SARA reference: 2604-51886 SRA
 Council reference: CA 2025_5880/1
 Applicant reference: 2025-09-82 - Seymour Group

SARA referral agency response – 71-85 Port Douglas Road, Port Douglas

Description:	Development permit	Reconfiguring a lot (1 lot into 40 lots and common property)
	Preliminary approval	Material change of use for use rights consistent with the low-medium density residential zone and to vary the effect of the planning scheme by amending the table of assessment for short term

TMR Layout Plan (6504 - 2.50km)

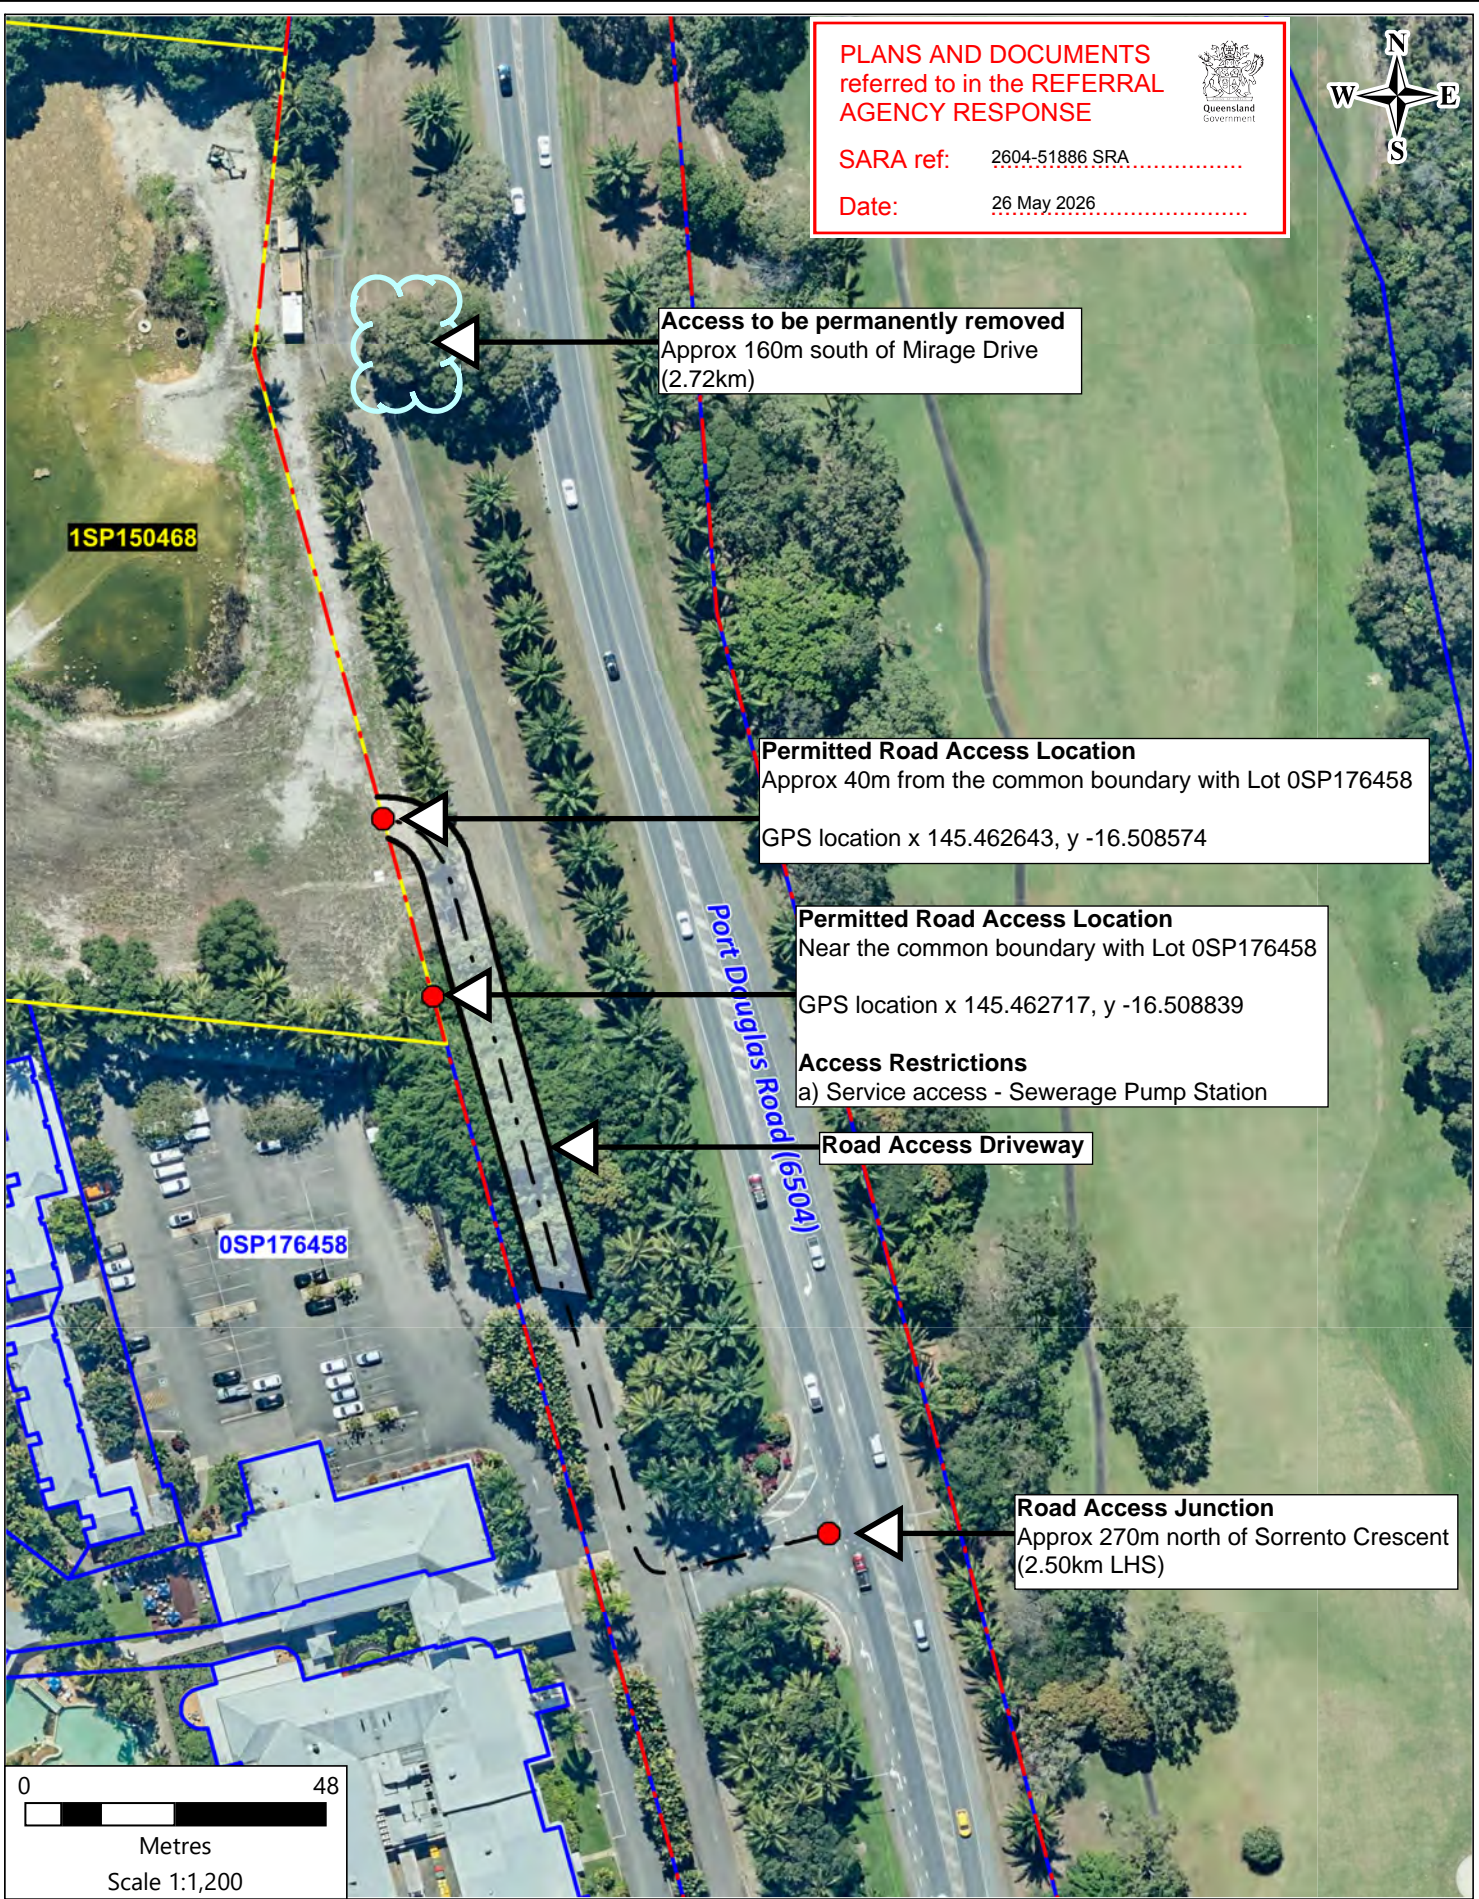
No.	Conditions of Approval	Condition Timing
Road Access Location		
A. General		
1	The Permitted Road Access Locations are: (a) Approximately 40 metres from the common boundary with Lot 0SP176458, (b) Near the common boundary with Lot 0SP176458,	At all times.

No.	Conditions of Approval	Condition Timing
	in accordance with: (i) TMR Layout Plan (6504 - 2.50km) Issue C 14/05/2026 TMR26-049812 Attachment D	
2	Direct access is prohibited between Port Douglas Road and Lot 1SP150468 at any location other than the Permitted Road Access Location described in Condition 1 and shown on: (i) TMR Layout Plan (6504 - 2.50km) Issue C 14/05/2026	At all times.
3	The use of the permitted road access location described in Condition 1(b) is to be restricted to: a) Service access for Sewerage Pump Station	At all times.
4	Road works comprising: a) Lengthening, widening and other modifications to the existing one way access between the Road Access Junction and the subject land. b) Widening and sealing of the road access driveway, c) Line marking must be provided generally in accordance with: <ul style="list-style-type: none"> • Road Planning and Design Manual, 2nd edition, Department of Transport and Main Roads, September 2025 and • Far North Queensland Regional Organisation of Councils (FNQROC) Standard Drawings. 	Prior to submitting the Plan of Survey to the local government for approval, and prior to the commencement of the use of the Road Access Works, and to be maintained at all times.

DRAWING TITLE		
PRELIMINARY ROADWORKS AND DRAINAGE LAYOUT PLAN		
PROJECT NUMBER	DRAWING NUMBER	REVISION
BE25041-001	DA200	1

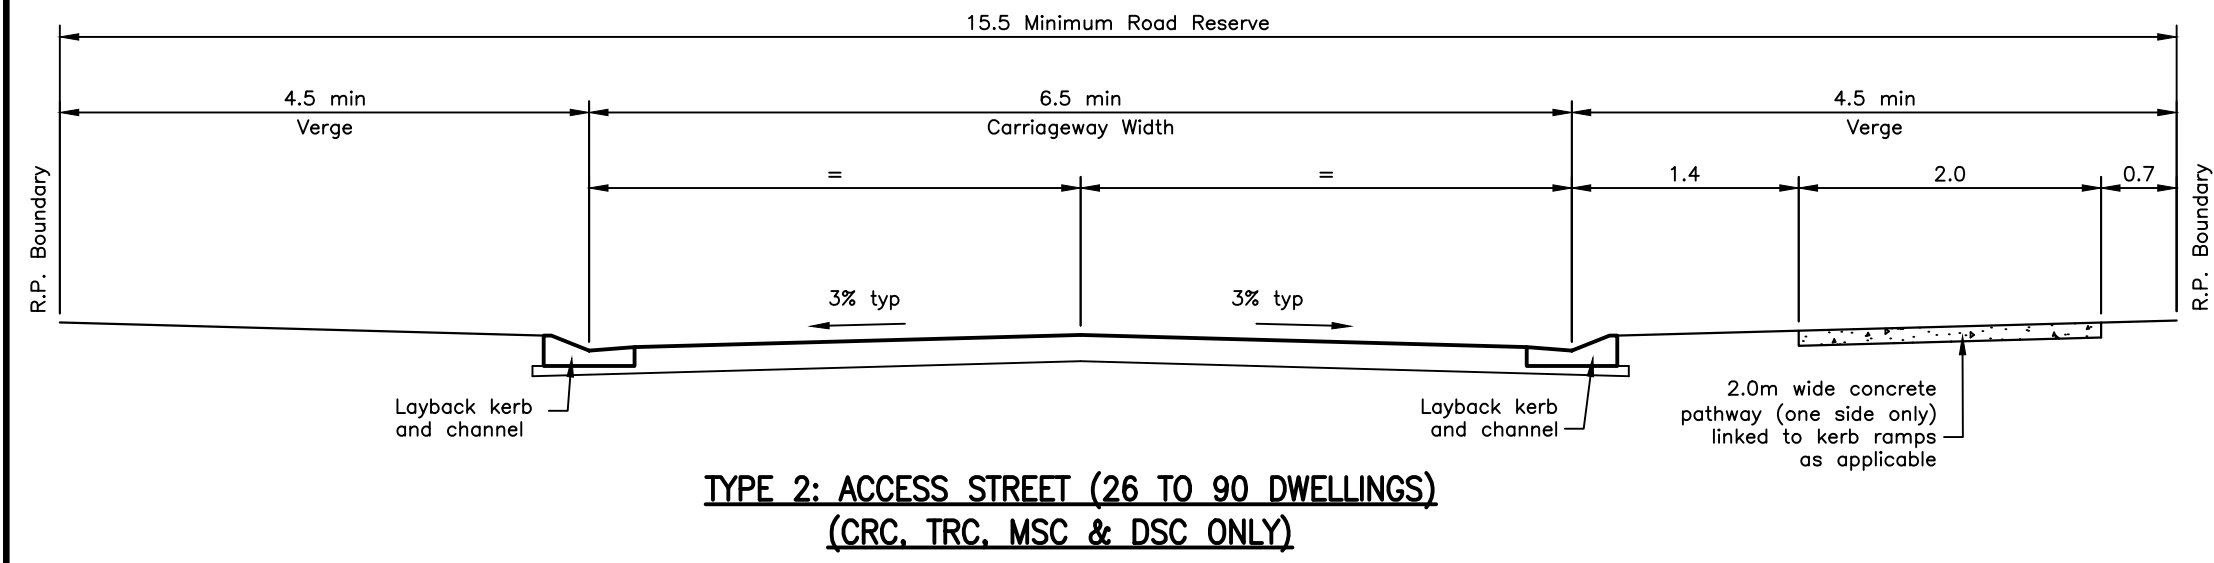
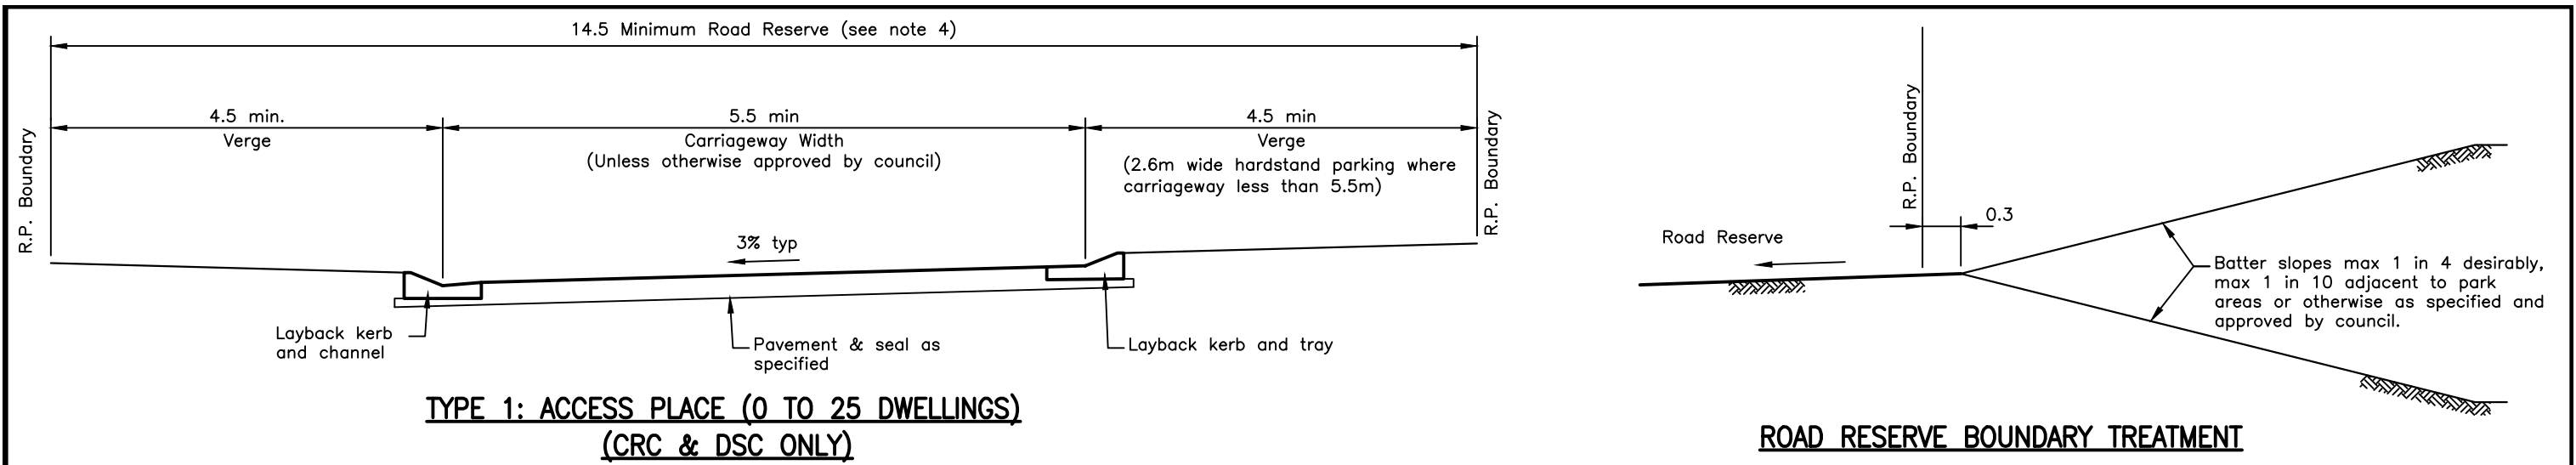
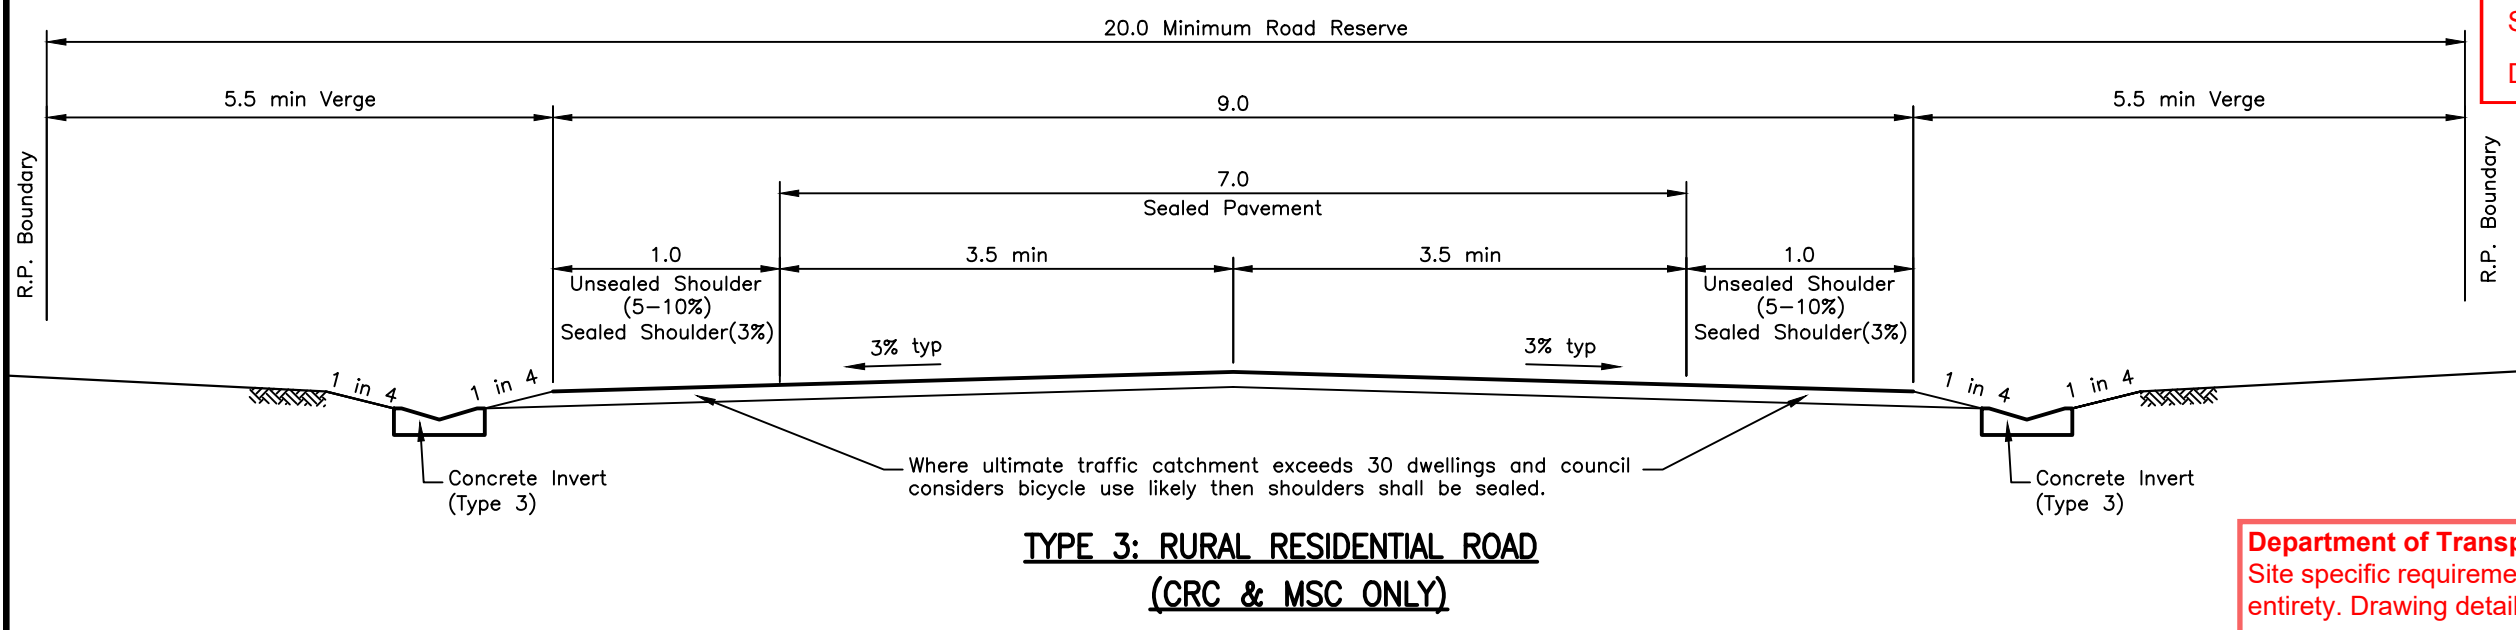
3.	<p>(a) Road accesses are located generally in accordance with Preliminary Roadworks and Drainage Layout Plan prepared by Bourn Engineers, dated 18.12.25, Reference DA200 and Revision 1, as amended in red by SARA.</p> <p>(b) Provide road access works comprising of a sealed two-way road access driveway with an appropriate width and sealed access crossover (service access) at the road access locations, referred to in part (a) of this condition generally in accordance TMR Layout Plan (6504 – 2.50km), prepared by Queensland Government Transport and Main Roads, dated 14/05/2026, Reference TMR25-049812, Issue C.</p> <p>(c) Design and construct the road access driveway works including the service access, referred to in part (b) of this condition, generally in accordance with:</p> <ul style="list-style-type: none"> • Volume 3 – Guide to Road Design of the Department of Transport and Main Roads’ Road Planning and Design Manual, 2nd Edition, September 2025; • Far North Queensland Regional Organisation of Councils (FNQROC) Standard Drawing S1005 – Typical Road Cross Sections Type 1, Type 2 & Type 3 dated 27/08/20, Revision E; and • Far North Queensland Regional Organisation of Councils (FNQROC) Standard Drawing S1015 – Access Crossovers, dated 05/12/23, Revision F. 	<p>(a) At all times.</p> <p>(b) and (c): Prior to submitting the Plan of Survey to the local government for approval.</p>

Road access locations and service road extension works as per condition 3 of the referral agency response

Amended in red by SARA on
26 May 2026
